Re: Responses to the Open House Comments for 1317 York Road, Niagara-on-the-Lake - Proposed 5 Townhouses and 1 Single-Detached Dwelling.

We acknowledge receiving the open house comments from the public on September 18, 2025. Please accept the responses to the public comments and reference that address the comments.

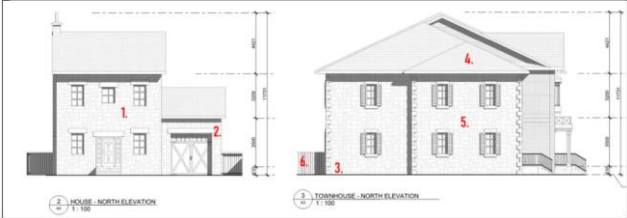
<p>Entrances Town Policy requires that all driveway accesses maintain a minimum setback of 8 metres from a corner property line. The required setback is measured from the exterior lot line to the closest point of the entranceway or curb cut. The current concept plan will need to be revised to show that the driveway access proposed for Townhouse Unit A is able to maintain a minimum setback of 8 metres. Please ensure that the full width of the driveway apron proposed at the road is considered as part of the setback requirement.</p> <p>Any driveways that are proposed to be shared between Townhouse units should include a clear delineation feature at the property line to ensure boundaries are known on-site for ongoing maintenance responsibilities between the separate units.</p>	<p>Noted. Addressed in site plan dated 09FEB2026. 1m setback maintained between interior lot lines for townhouses.</p>

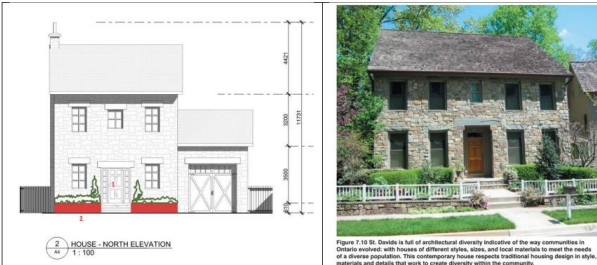
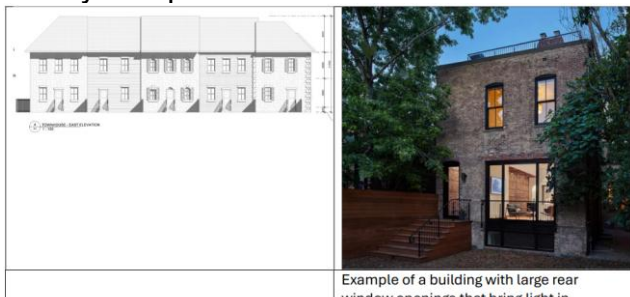
<p>Urban Design</p>	
<p>1. 7.1.1 Guidelines: Setbacks: The proposed design of 1317 York Road meets this guideline in full. The proposal has varying setbacks with front facing buildings and no rear lotting.</p>	<p>Acknowledged,</p>
<p>2. 7.1.5 Guidelines: Massing: The proposed design of 1317 York Road meets this guideline in full and does</p>	<p>Acknowledged,</p>
